**ARCHITECTURAL REVIEW BOARD  
CITY OF FREDERICKSBURG, VIRGINIA  
AGENDA  
September 12, 2016  
7:00 P.M.  
COUNCIL CHAMBERS, CITY HALL**

**TO:** ARCHITECTURAL REVIEW BOARD  
**FROM:** Kate Schwartz, Historic Resources Planner  
**DATE:** August 8, 2016  
**SUBJECT:** Certificate of Appropriateness for demolition and new construction at 100 Hanover Street  
 1<sup>st</sup> review for demolition and site planning, scale, and massing

DECK for SPENCER DEVON BREWERY  
 823 CAROLINE STREET  
 FREDERICKSBURG, VIRGINIA

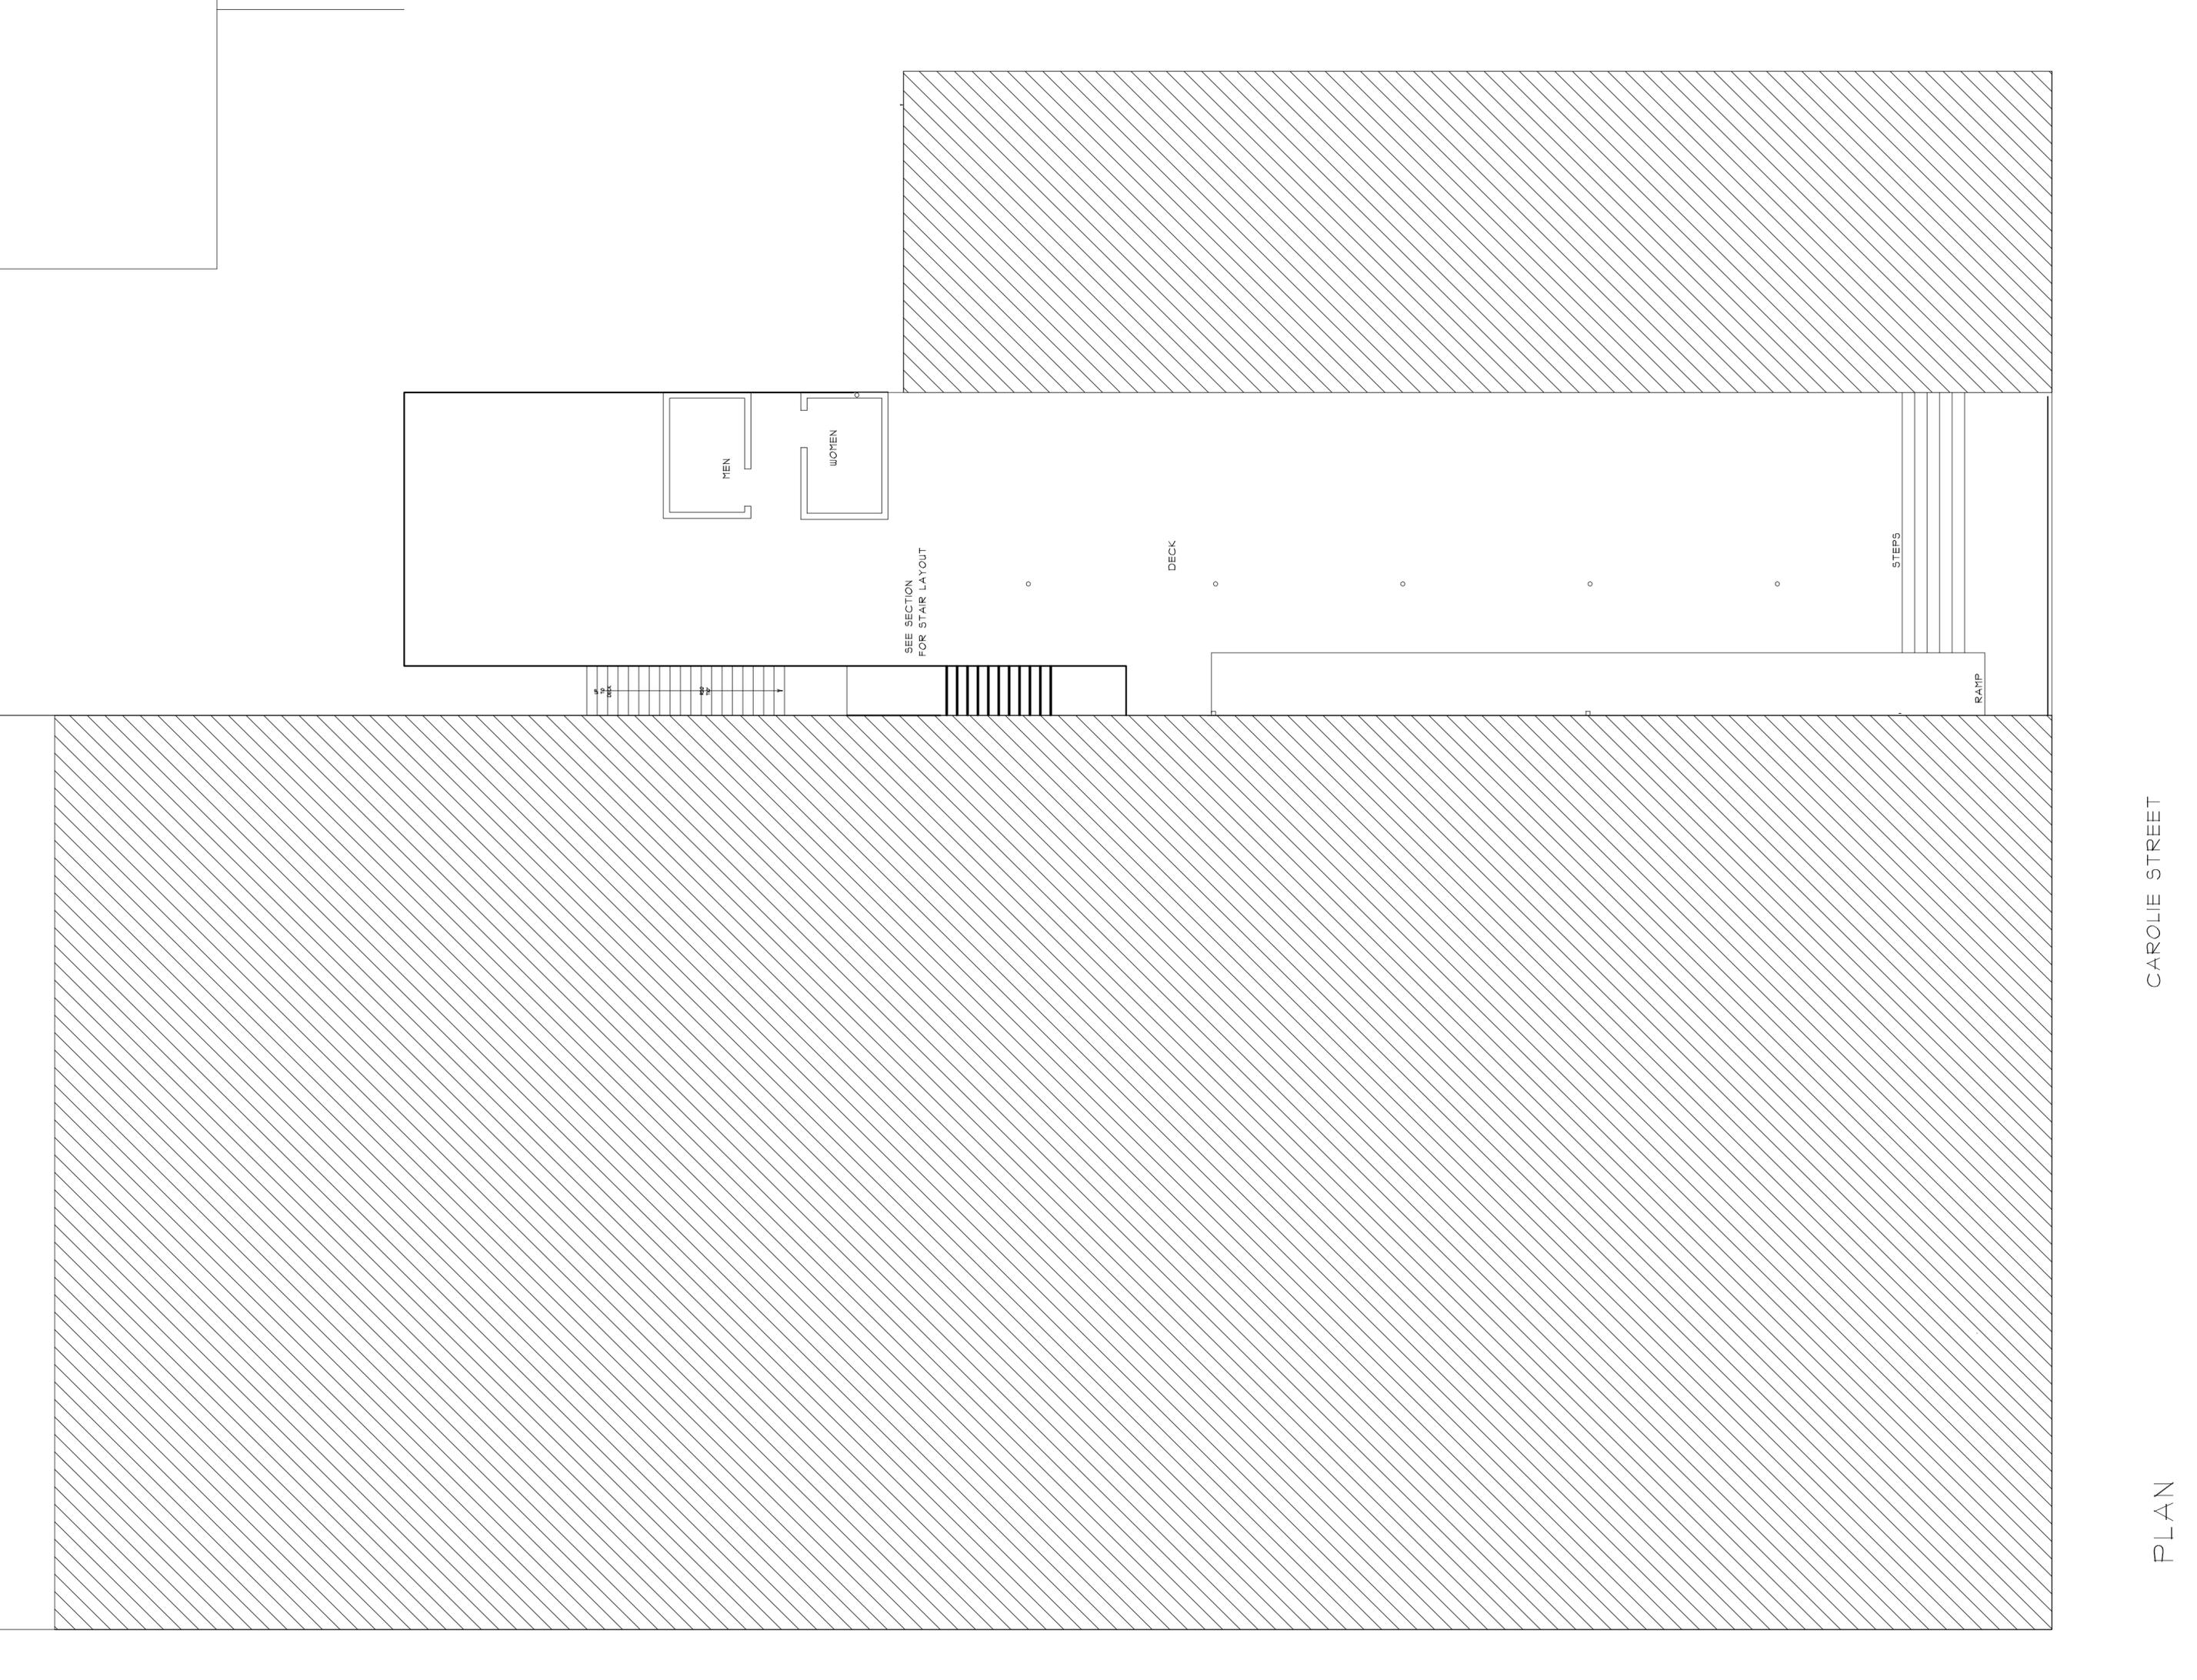
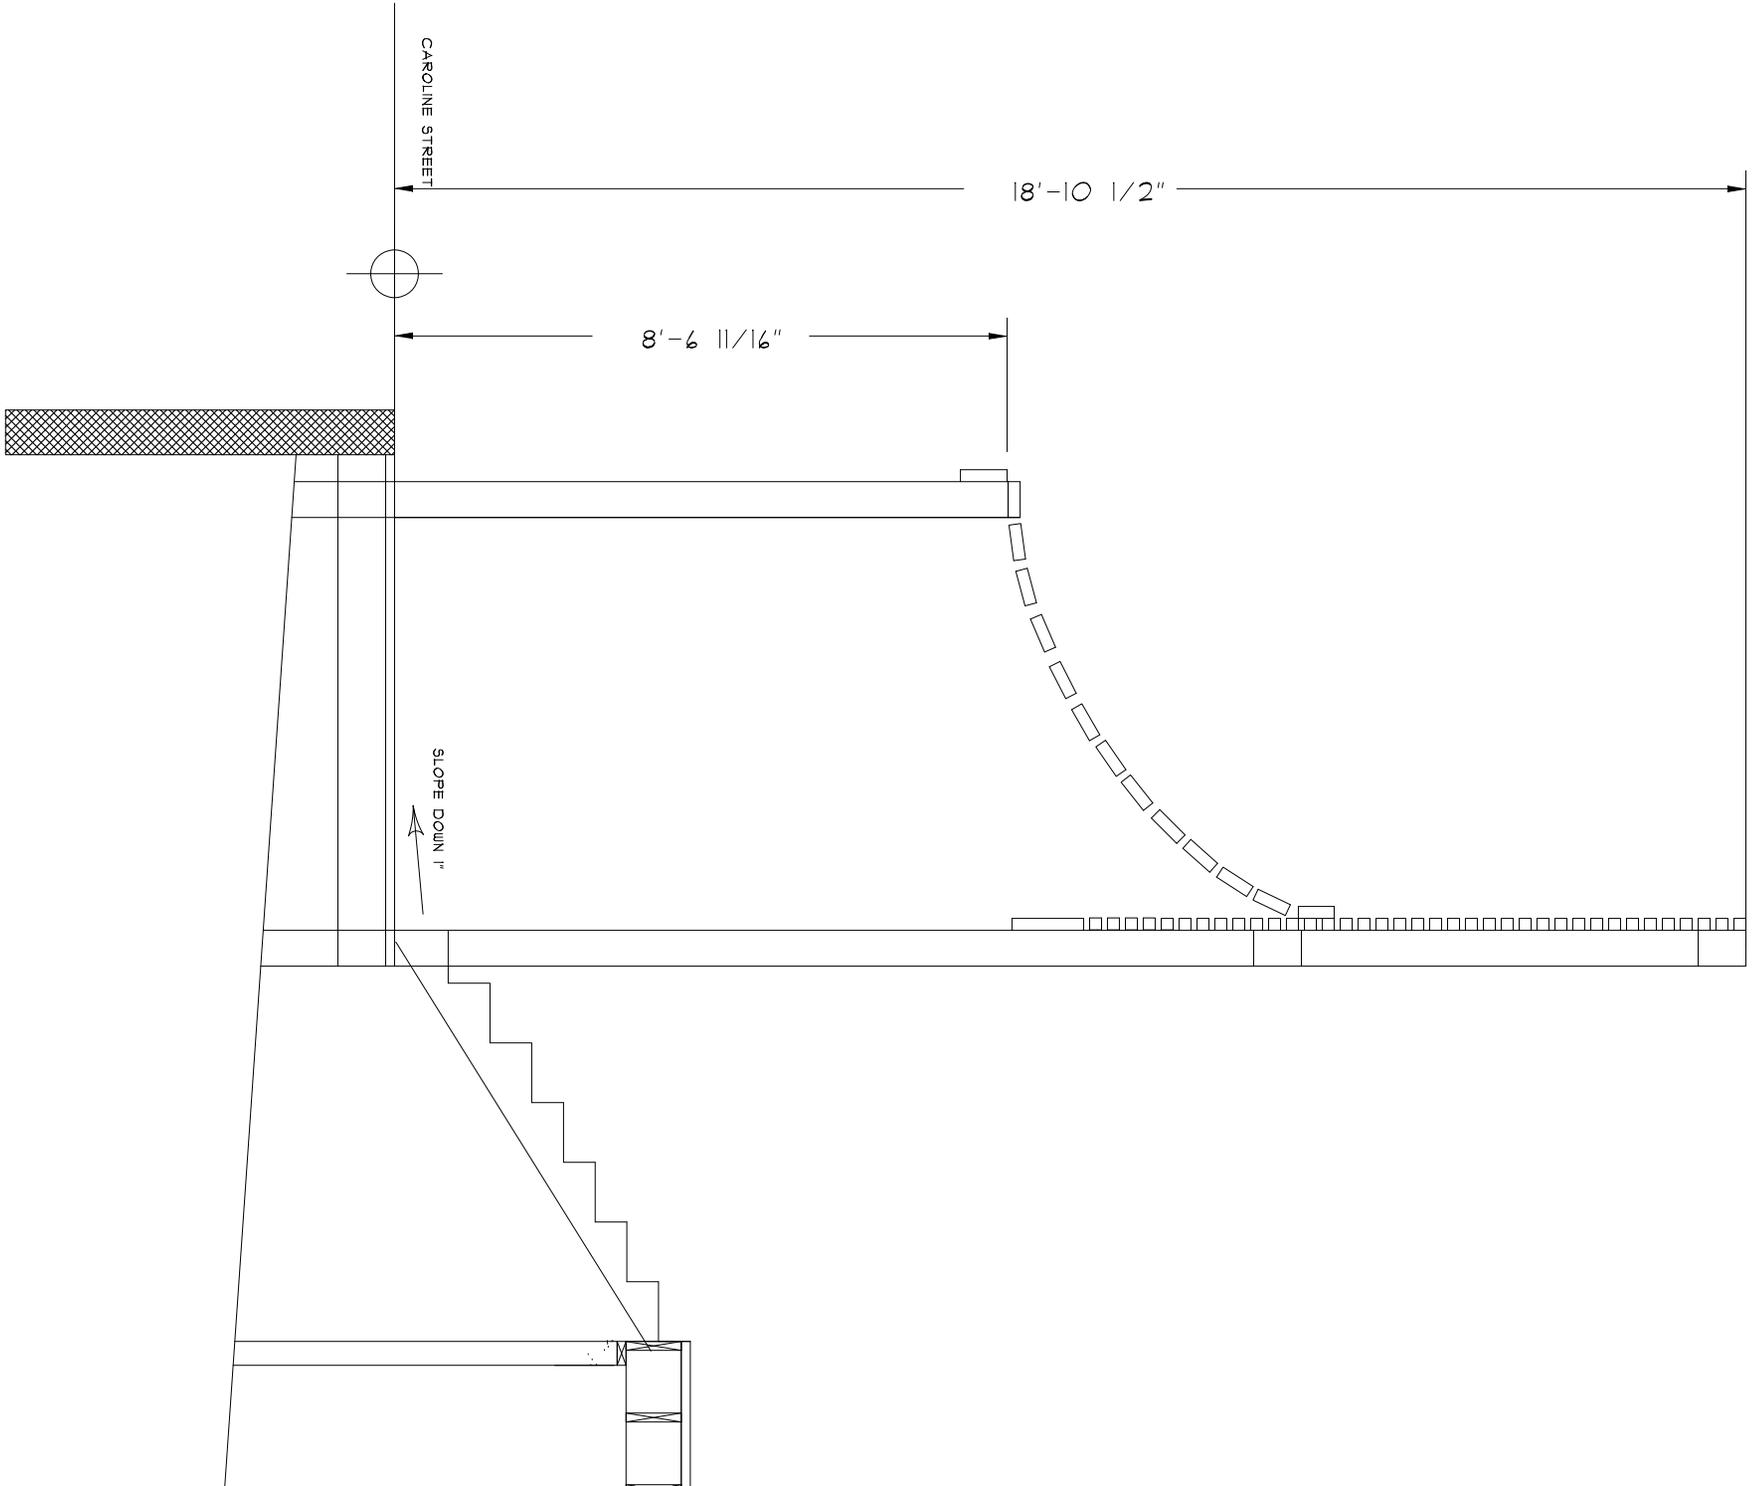
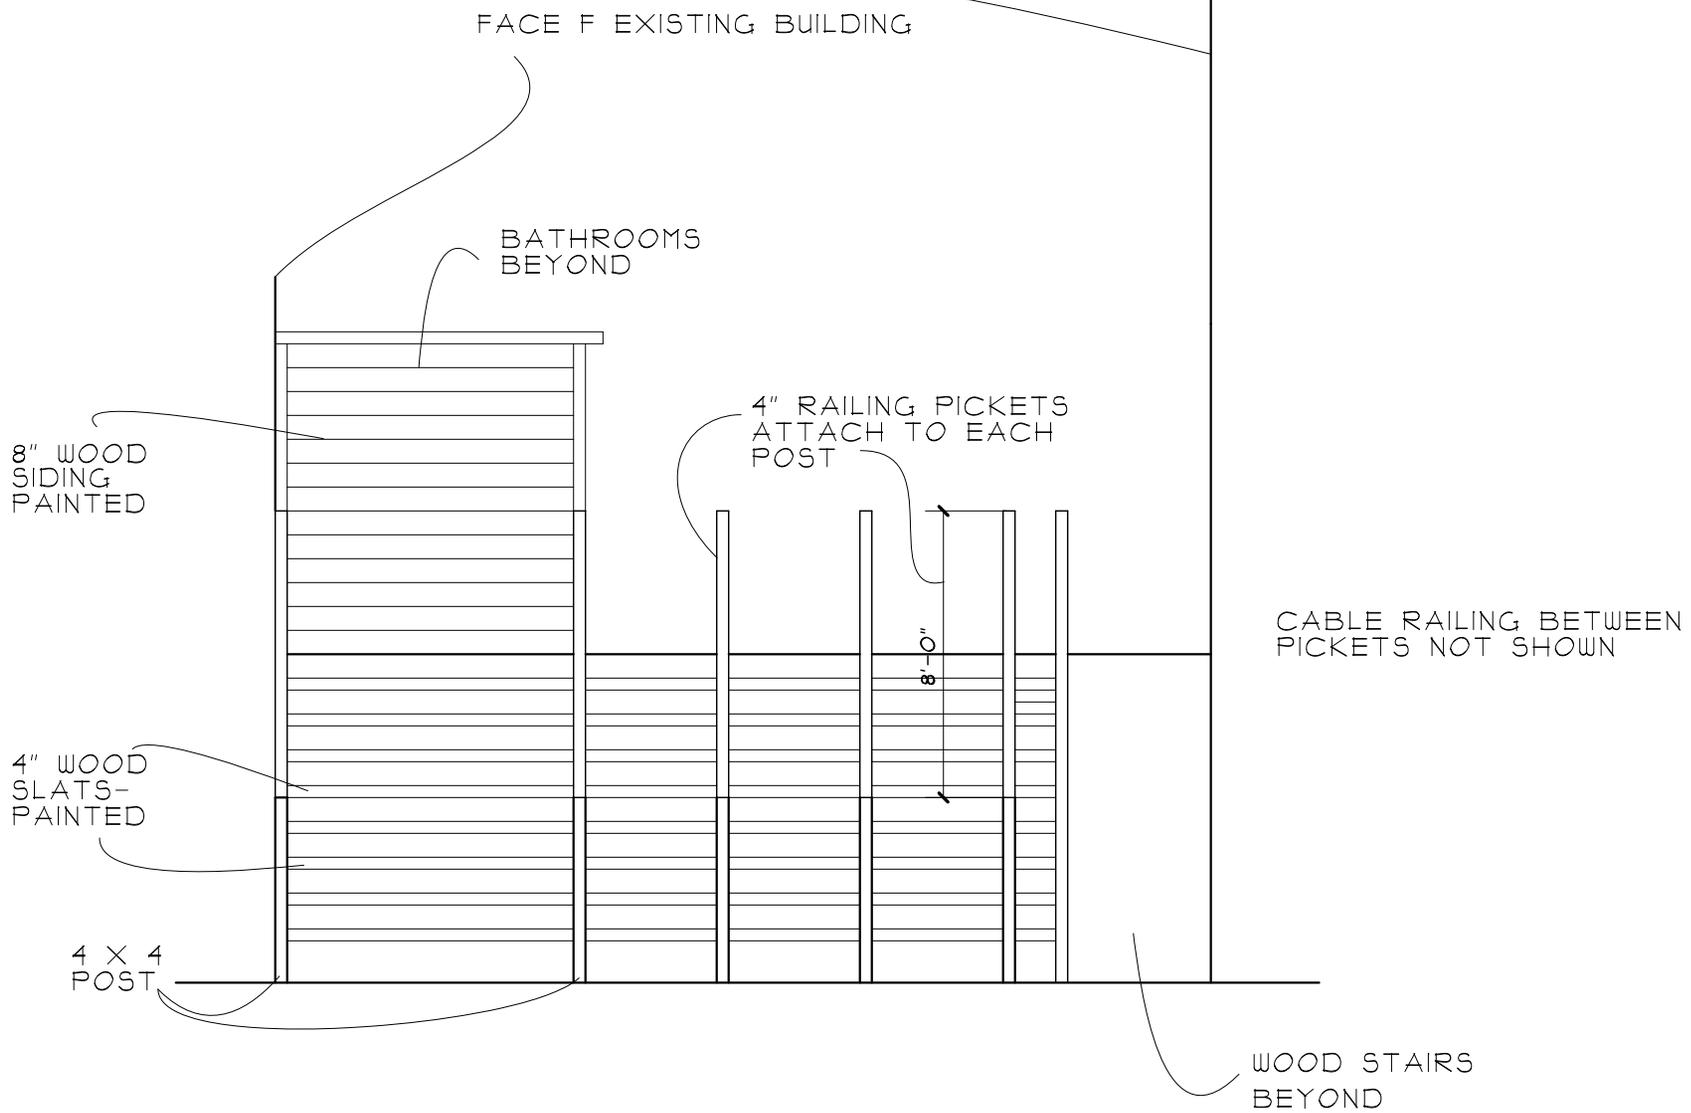
**The site planning, scale, and massing of this structure is consistent with traditional patterns throughout the Historic District and approval is recommended.** A second public hearing will be held to evaluate the materials, design details, and the project in its entirety. At that time, the applicant should be prepared to discuss:

- Materials and material finishes including the deck surface and railings
- Any signage and exterior lighting
- Consideration of screening at the rear of the deck to hide the underside of the deck
- Additional detailing of the façade. Consider incorporating a heavier/more substantial element at the top of the façade to present a more substantial appearance in balance with the neighboring buildings.
